# MEMO

**Date:** April 14, 2010  
**To:** Steve Lester *SL*  
**From:** Craig Tesch and Sean Vincent *CT SV*  
**cc:** Rick Raymondi  
**Subject:** Technical Review of Groundwater Modeling in Support of Idaho Water Company Water Right Transfer #73811

**Date:** 18 February 2010  
**To:** Craig Tesch  
**From:** Allan Wylie *AW*  
**cc:** Rick Raymondi, Sean Vincent  
**Subject:** Review of Shekinah Model

Figure 3. Spring 2000 water level contours for the Mountain Home groundwater monitoring network (Harrington, 2001).

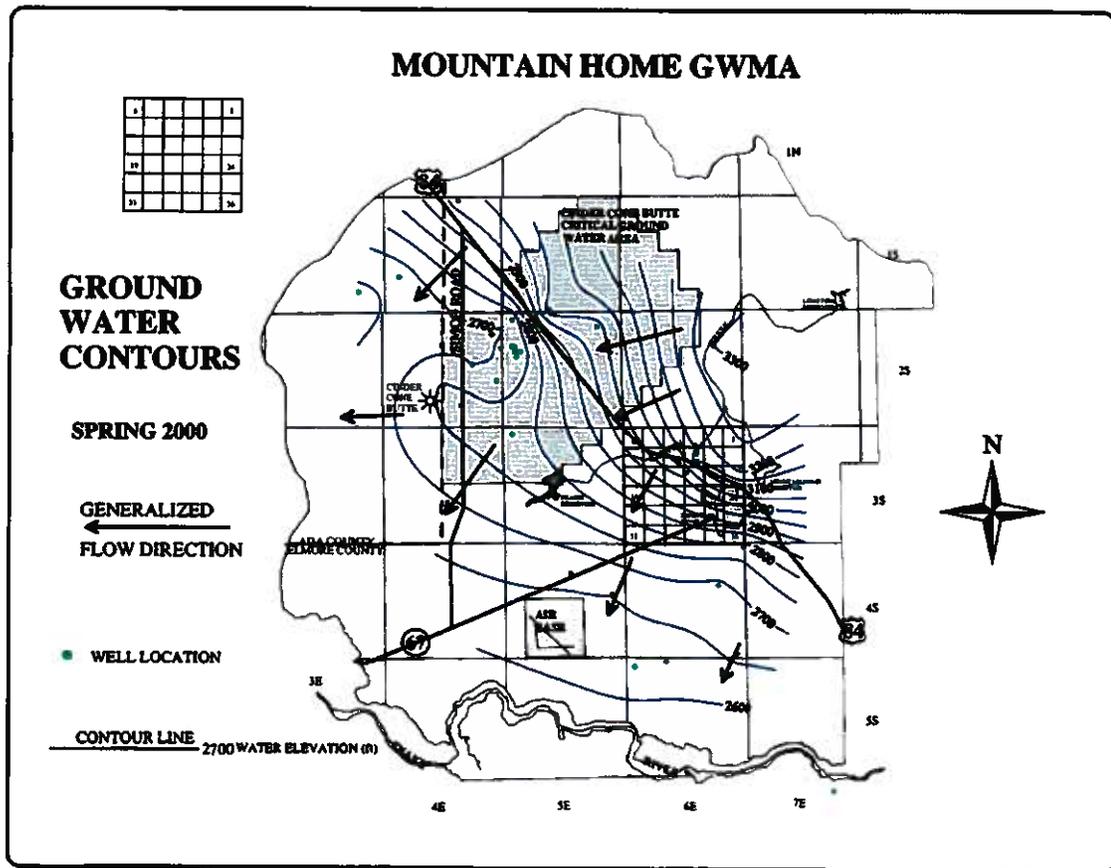
It is unclear why contours were used for calibration instead of the water levels from which they were developed. More commonly, groundwater models are calibrated to

actual water levels and goodness of fit is calculated by comparing simulated heads to measured water levels. The statement in the modeling report that “no current published groundwater contours were available for the region” (Powell, 2009, p. 23) does not explain the rationale for deciding to not use recent water level data for model calibration. In fact, a groundwater contour map could have been created from the 2000 water level data (see Figure 3) or from the 2009 data.

Figure 4. Groundwater level change from spring 1983 to spring 2009 within the IDWR Mountain Home monitoring network.

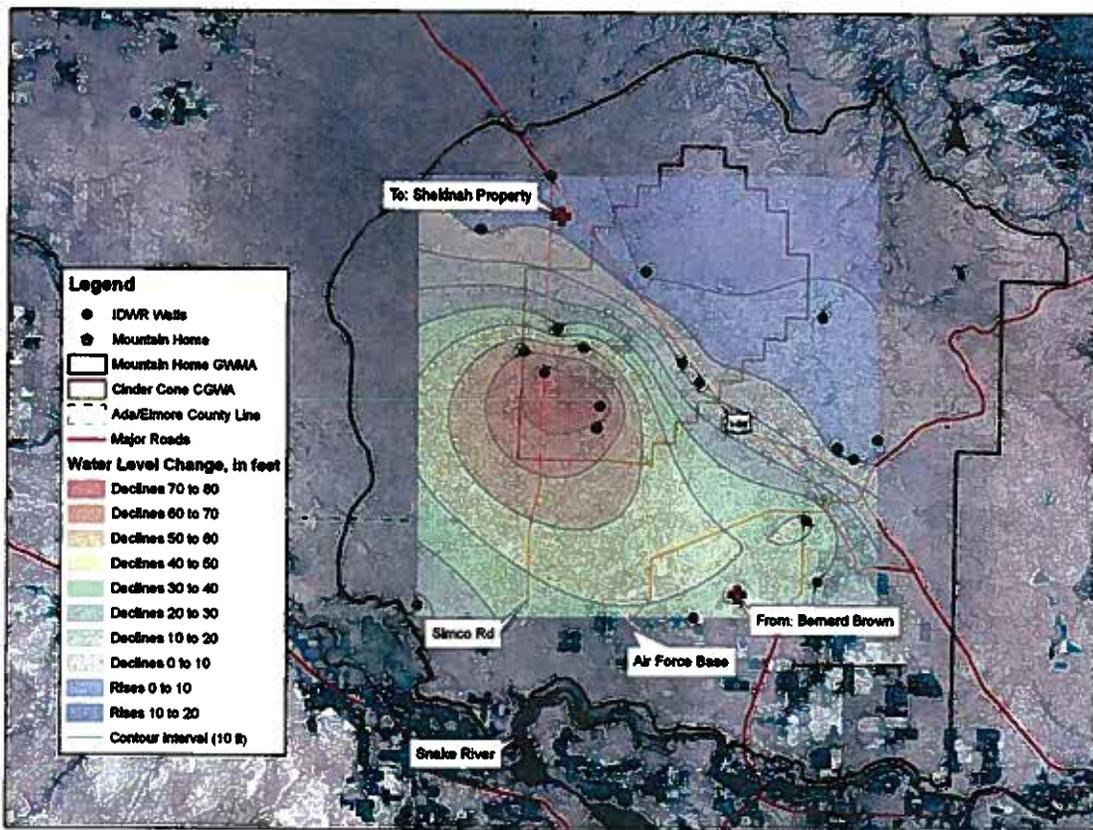
Five of the six wells in which water level increases were observed are located northeast of interstate I-84. The current PODs are located in an area with declines of 30 to 40 ft over the last 26 years, while the proposed PODs are in an area in which the water level

has risen from 0 to 10 ft. The cause of differing trends is currently unknown; there is significant uncertainty about aquifer behavior in this area due to a general lack of hydrogeologic data.

Northwest-trending faults mapped in the area (Bond, 1978) may serve as partial barriers to flow and contribute to the difference in trends between wells north/northeast of I-84 and those south/southwest of I-84. Additionally, irrigation development near Simco Road in the southwestern portion of the CGWA likely is affecting the distribution of water level declines. Studies performed as part of the IDWR Treasure Valley Comprehensive Aquifer Management Planning (CAMP) program will provide hydrologic information to facilitate a more rigorous evaluation of the factors affecting water levels in the GWMA and CGWA.

Large differences in groundwater level trends exist between the locations of the current and proposed POU (Figure 4). As Brockway Engineering states, “The groundwater elevations near the northwest portion of the Cinder Cone Butte Critical Groundwater Area have been experiencing a slight increase in elevation over the last few years, while the area near the southeastern portion of the critical groundwater area have seen steady declines” (Powell, 2009, p. 25). The extent to which stable or increasing trends in the vicinity of the proposed PODs could offset any pumping effects is unknown.
